Safety and Airspace Regulation Group		
Page 1 of 17	Airspace Change Proposal - Environmental Assessment	Version: 1.2/ 2019

`Title of Airspace Change Proposal	Introduction of Southend CTA 10X and CTA 11
Change Sponsor	London Southend Airport
SARG Project Leader	
Case Study commencement date	02/03/2020
Case Study report as at	01/04/2020
File Reference	ACP-2017-25

Figure 1 - Airspace configuration around London Southend Airport including the proposed CTA-10X and CTA-11.2

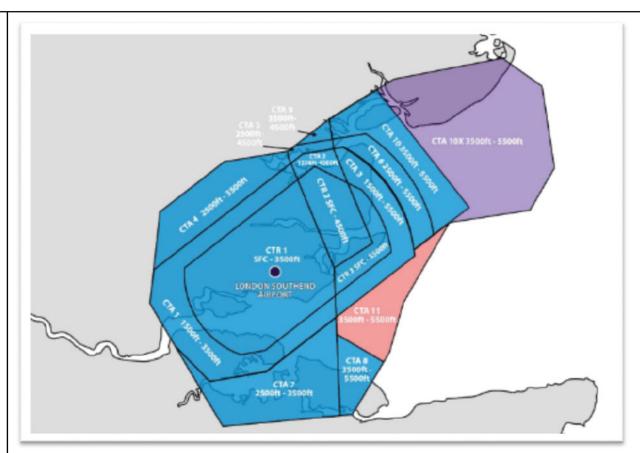
4.1 Is it clear how the proposed change will operate, and therefore what the likely environmental impacts will be? Yes The proposed change seeks to implement controlled airspace in the form of two control areas, CTA-10X and CTA-11. The majority (90%) of the airspace encompassed by CTA-10X and CTA-11 is located over the North Sea and therefore the likely impact to stakeholders on the ground is deemed to be minimal. The base level of both CTA-10X and CTA-11 is 3,500ft, with the upper level being 5,500ft. The GEGMU hold is currently not used in a meaningful way by LSA controllers due to its location being in Class G uncontrolled airspace which is unsuitable for holding commercial traffic. With the introduction of CTA-10X, the GEGMU hold would become encompassed by controlled airspace, therefore providing controllers with the option to safely use the hold which is located over the North Sea, away from populated areas and therefore likely to enable an unquantifiable noise benefit. Although the GEGMU hold is not meaningfully used by LSA controllers, arriving aircraft from the from the east and south-east already pass through CTA-10X using STARs that terminate at the GEGMU holding fix. CTA-11 provides controlled airspace to the south-east of the airport, an area through which some arriving aircraft from the east pass through when landing on runway 05 (south-westerly arrivals). This ACP does not seek to change any existing IFPs and no controlled airspace over that requested in ACP-15-01 is being sought. Given the technical nature of this ACP and absence of changes to defined IFPs and routes, the likely environmental impacts are anticipated to be negligible, with an unquantifiable environmental benefit being suggested by the Sponsor. 4.2 Have alternative options been considered, and have the environmental impact of each alternative been assessed? No Alternative options were not considered for this ACP. The airspace being sought in this ACP (CTA-10X and CTA-11) was originally requested in ACP-15-01 which was submitted to the CAA in 2014. As mentioned in section 1 above, in the CAA's 2015 decision letter for the previous ACP, the majority of the airspace requested by LSA was approved, except for CTA-10X (a portion of CTA-10 at the time of the original ACP) and CTA-11 for which the CAA made the provision for future introduction on the basis that certain parameters were met. This ACP seeks to provide the relevant justification required to allow for the implementation of CTA-10X and CTA-11.
